PREVOST

Warranty Bulletin

96-04

Date: **April 1996**
 Section: **18**
 Subject: **Frame Reinforcement**
 Application:

FIGURE 1: ENGINE COMPARTMENT

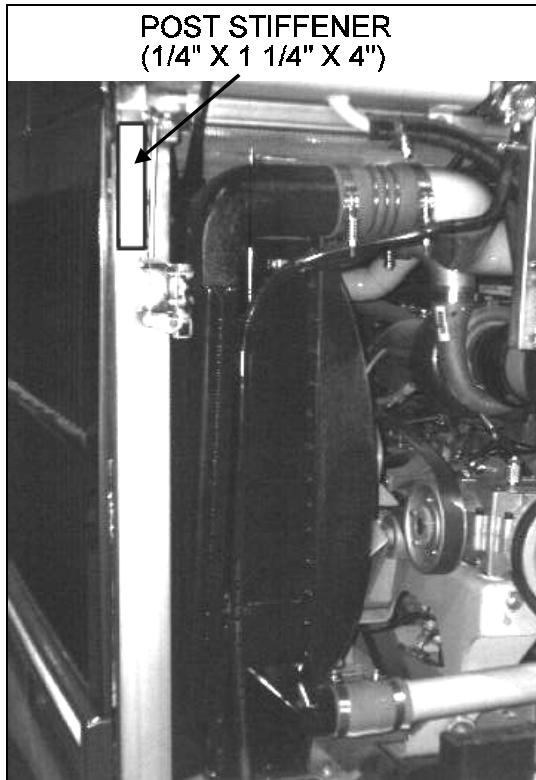
The Prévost Car engineering department has recently made an improvement on the H3 Series vehicle engine rear door structure. The purpose of this modification is to reinforce the connection of the rear left vertical post to a perpendicular beam. It is recommended that you do this modification by performing the following procedure.

1. Open rear engine door.
2. Locate the rear left vertical post (Fig. 1).
3. Open radiator door (to protect paint).
4. Clean and grind post surface to reasonable flatness.
5. Protect paint from sparks with fireproof material.
6. Weld the stiffener on the post as per figure 2. Refer to the General Welding Procedure in this Warranty Bulletin.

POST STIFFENER
(1/4" X 1 1/4" X 4")
